LOWER SNAKE RIVER LITTLE GOOSE AND LOWER GRANITE LOCKS AND DAMS

**Adult Fishway Systems
Emergency Auxiliary Water Supply
Phase II – Technical Report**

Final Report

Appendix A	Quality Control Plan and Independent Technical Reviews (ITR)
Appendix B	Technical Review Comments and Meeting Minutes
Appendix C	Construction Cost Estimates – Little Goose
Appendix D	Construction Cost Estimates – Lower Granite
Appendix E	References

SOUTH NON-OVERFLOW DAM - PLAN

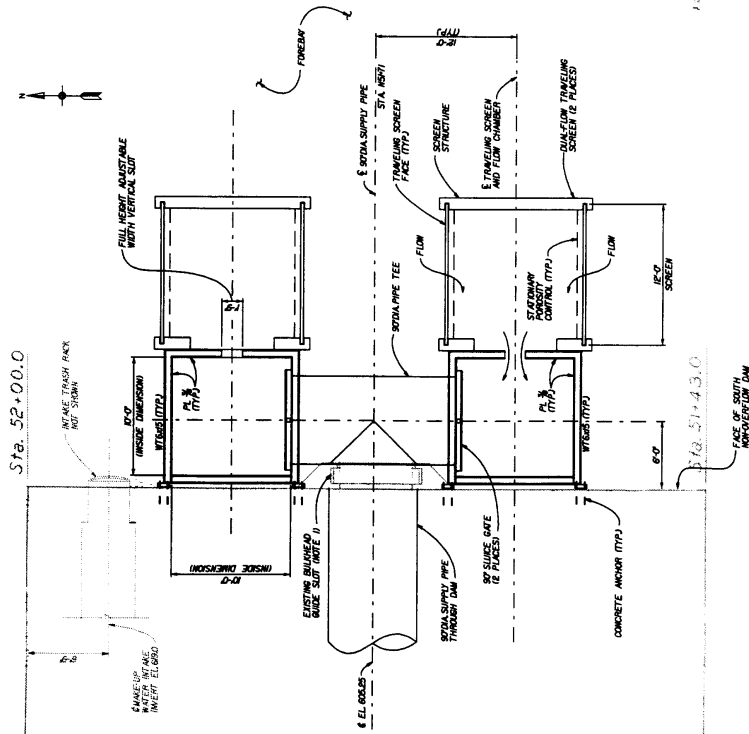
9	Plate 1.1.1	Will butterfly valve be able to regulate properly given the number of bends in the line both upstream and downstream of the valve?	A – For butterfly valves, optimum location is 5 pipe diameters downstream of an elbow. This can be reduced if the orientation of the valve is adjusted to reflect the plane of the upstream elbow. There are about 5 pipe diameters upstream of the valve. No restrictions on downstream bends, etc. are known.	NA	MRV
10	Plate 1.1.2	Pipe ring stiffeners may be needed. This should be reviewed.	A – Pipe ring stiffeners would be required at the pipe support locations. These will be shown where supports are required.	C	MRV
11	Plate 1.1.2	Additional pipe support(s) may be needed in the more or less vertical section of 90-inch diameter pipe.	A – See response to comment No. 7	NA	MRV

PLATE 11.3

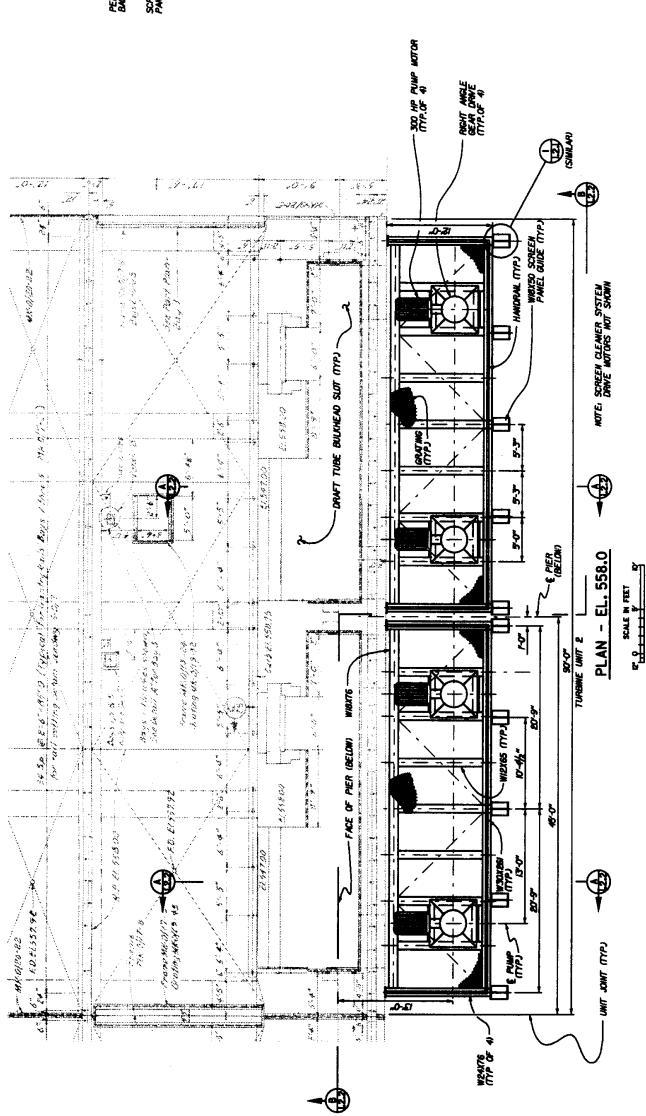
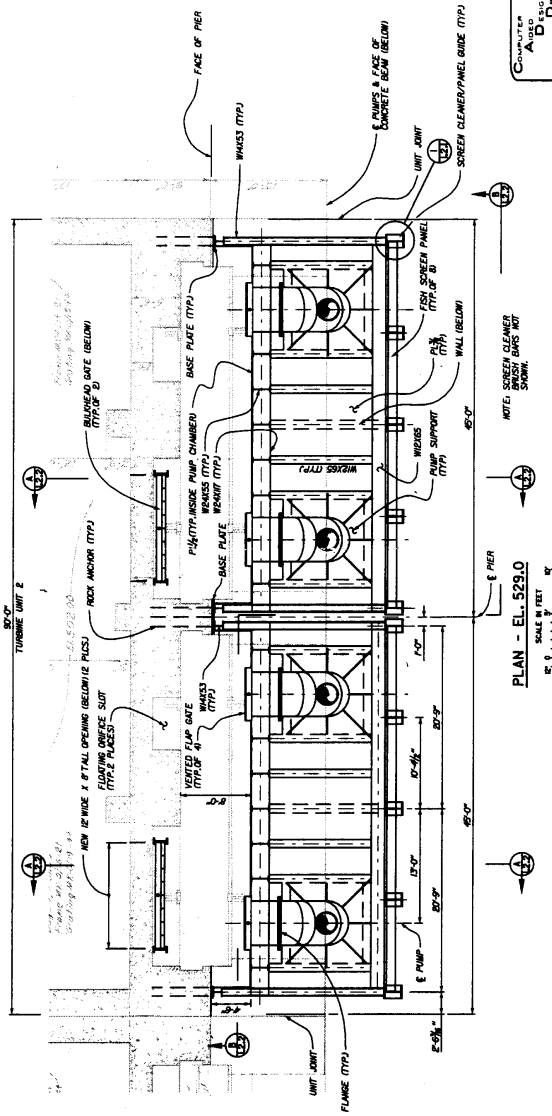
3.	Plate 1.1.3	What are the existing guides where the new gravity pipe is penetrating the dam used for? The drawing says it's an existing bulkhead guide. And note 1. Says to remove the guide where the pipe penetration is. Is the guide something that is going to be installed prior to the pipe and then removed? Or is it and existing guide that may be needed again in the future and will not be available?	A - The guides are no longer used. They were part of the temporary fish ladder which was used during construction of the dam.

30	Plate 1.1.3	Will there be any annunciation for screen plugging? There are no details on the screen guides, drive system, debris removal system, screen material, or screen panel mounting arrangement. The DDR does not contain any catalog information on this system.	A - The lack of annunciation was mentioned in the ITR, also. The text will be revised to note that. A copy of the vendor information on the screen will be added to the DDR in the cost estimates (typical costs).	
31	Plate 1.1.3	Explain the provisions for removing and/or cleaning the trashracks.	A - It was envisioned that the racks would be cleaned in the same manner that the AWS intake racks are cleaned. According to the project, they are lifted clear of the guides and "schwooshed" off in the water with a crane. Residual material is picked clean by hand. This will be noted in the text.

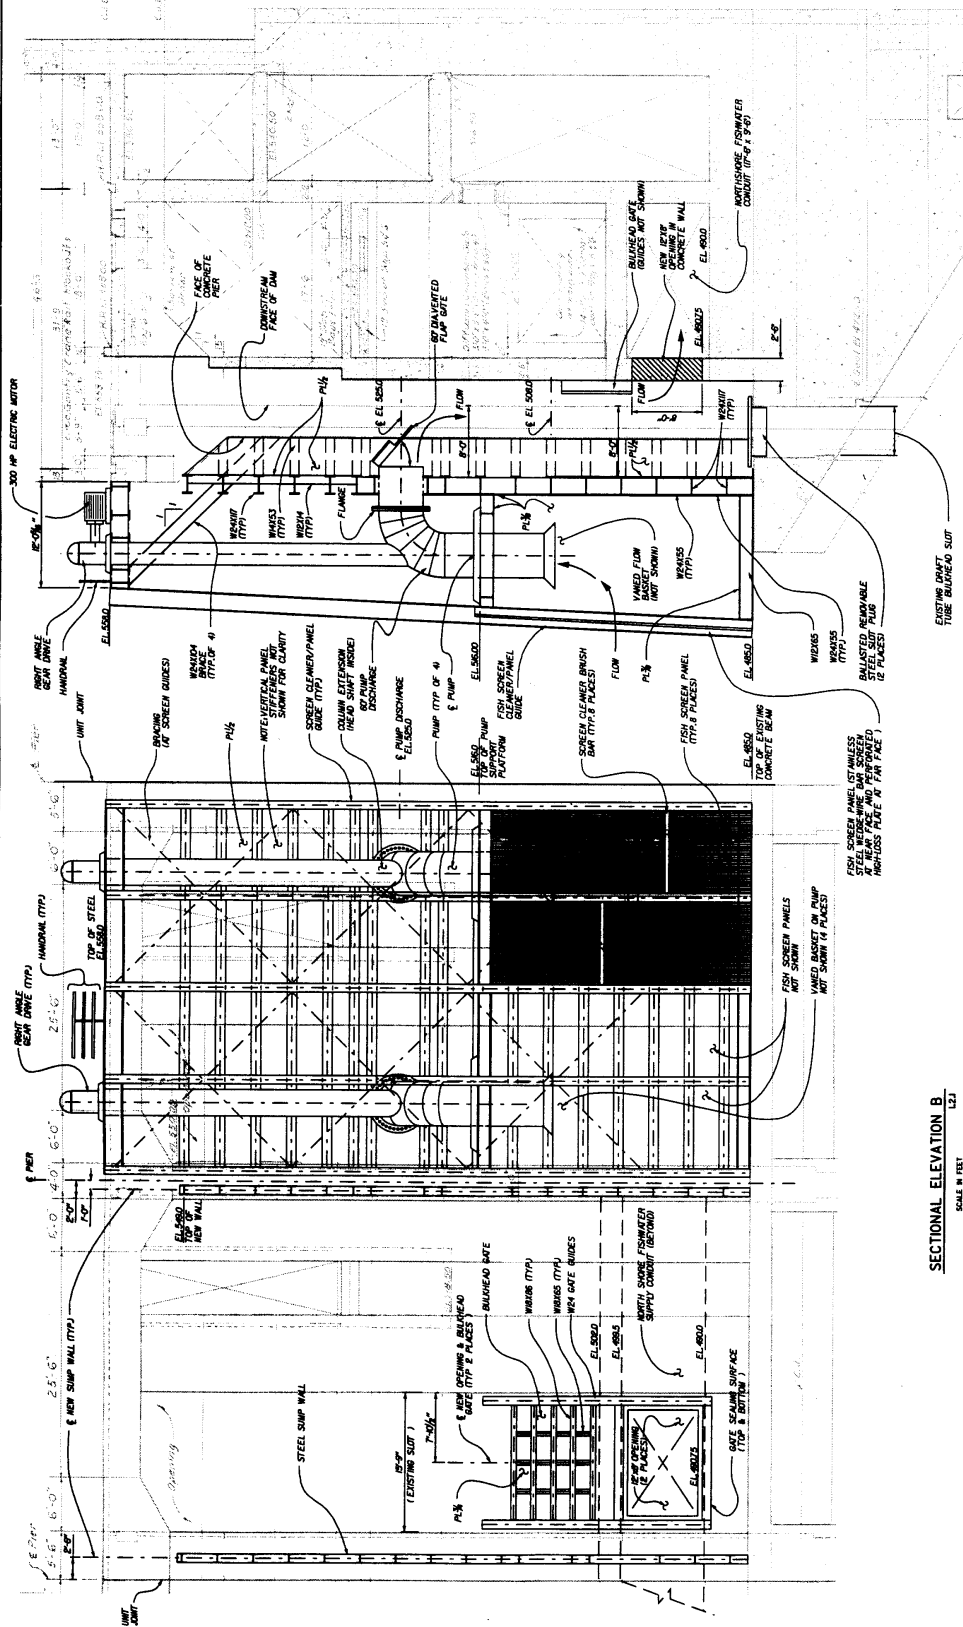
8	Plate 1.1.2	Where it leaves the south non-overflow downstream dam face, the 90" steel pipe could be turned down to vertical with a 90 degree bend and then sloped parallel to the dam toe with a 37 degree bend. This allows a simpler attachment to the dam face at two locations. The attachments can share the loads instead of concentrating them at the one at the base. Design, fabrication and installation of the supports, and maybe the pipe, should be easier.	A - I agree. We will review this and incorporate this change into the design if it checks out.	C	KBF
9	Plate 1.1.2	The valve pit is shown with the rim above the ground. Is this needed? There may be advantages to keeping it flush with the surrounding pavement.	A - Among other things, it eliminates the need to make it driveable (even with a curb around it, I would be afraid of it being driven on. We can also totally eliminate the grating and handrailing if the grating were eliminated.	NA	KBF

10	Plate 1.1.2	Means of access to the pipe interior for inspection and/or maintenance is not shown. Should it be provided?	A - Some provision for access should be made. It will be noted on the drawings that an access port will be included, located in the valve pit.	C - Noted in text but not shown in drawings.	KBF
11	Plate 1.1.2, 3	The flow chamber walls should use structural tee sections (WT) welded to the steel wall plates in place of the W sections shown.	A - We will review that.	C	KBF
12	Plate 1.1.3	Plan - El. 651.0: Will the platform bracing and interior framing at the deck level need to be removable to allow access for maintenance or replacement of the sluice gates?	A - Yes. This will be noted in the report. All deck framing is assumed to be bolted so removal of discrete steel members should be possible if plans are made for it.	C	KBF
13	Plate 1.1.4	Section B: The "Longitudinal Support" may be better provided by a shear attachment to the thicker wall along the pipe. The "Longitudinal Support", or the penetration at the south wall, will also take the hydraulic thrust from the pipe end cap.	A - Probably. A horizontal brace back to the wall would work. In truth, the thrust will likely be taken by the 7' thick wall. Thrust restraints will be shown on the drawings at the pipe penetration (embedded thrust rings on the pipe).	C	KBF

7	Plate 1.1.2	Additional thrust restraints appear to be necessary by either depiction or callout.	<p>A - This will be reviewed. The pipe coming out of the dam is being revised to a vertical 90-degree elbow followed by a vertical 37-degree elbow to follow the slope of the toe of the dam. This will provide additional support. A restraint at the 90-degree elbow may still be required. Restraints below grade will be called out. Text notes that they would be required.</p> <p>C</p>	MRV
8	Plate 1.1.2	Flow conditions immediately downstream of the butterfly valve in combination with a pair of bends is not likely to be uniform.	<p>A - The diffuser is a high-loss element that is not sensitive to uniform flow conditions in the pipe. This should not be a problem.</p> <p>NA</p>	MRV

5	Plate 1.1.2	Installation of two combination air/vacuum valves appears to be sufficient for the length of the supply pipe. However, a waterhammer analysis should be done (if this option is pursued beyond the Phase II level) to verify system pressures during critical operating scenarios, such as closing or opening the flow control valve (72-inch sleeve valve) and the sluice gate.	A - Agree	NA	MR

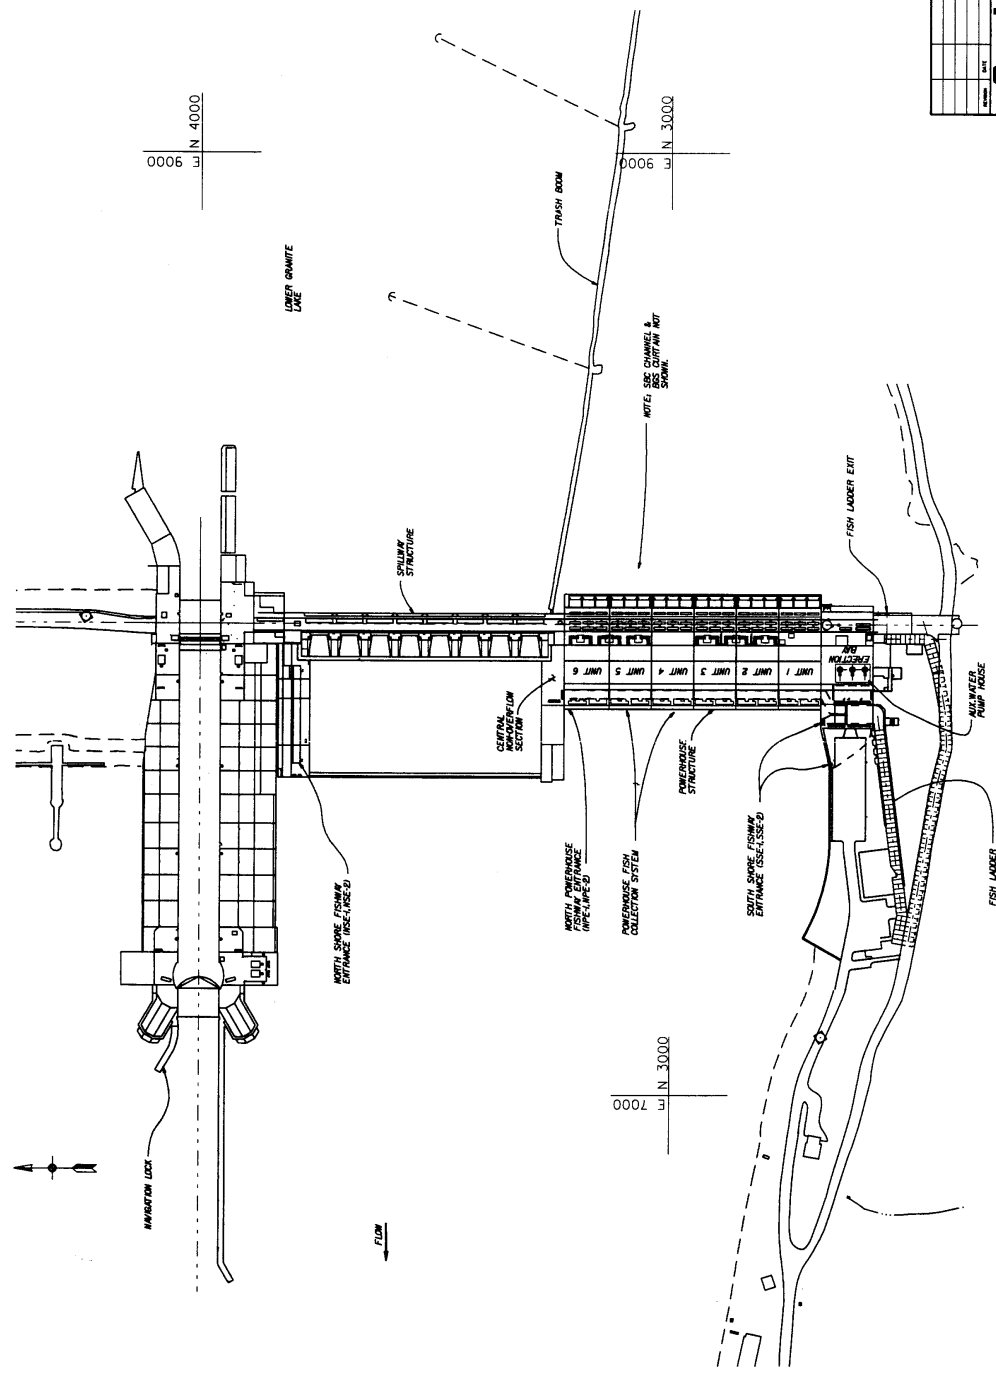
1	Plate 2.1.1	Substation scheme shows separate ATS and pump switchgear line-up with withdraw type fuses and motor contactors. The other 5kV switchgear schemes for the Little Goose alternate 2 and 3 show combined ATS with the pump switchgear. I would assume the switchgear line-ups to be the same for all except for hp ratings.	A - This is correct. All schemes are physically similar, except for the horsepower ratings. Drawings will be revised.	C	DMT
2	Page 4-39: Wicket Gate Sticking	Considering the problems with both mechanical and electrical operation with the wicket gates, the conclusion reached may need rethinking. A hydraulic gate operator with dithering circuit may solve both mechanical and electrical problems.	A - This will be discussed further at 60% meeting. Alternate can be priced and evaluated if USACE believes warranted. (Note: USACE has opted for cycling gates on regular basis at 60% Review meeting - GBW)	C	DMT
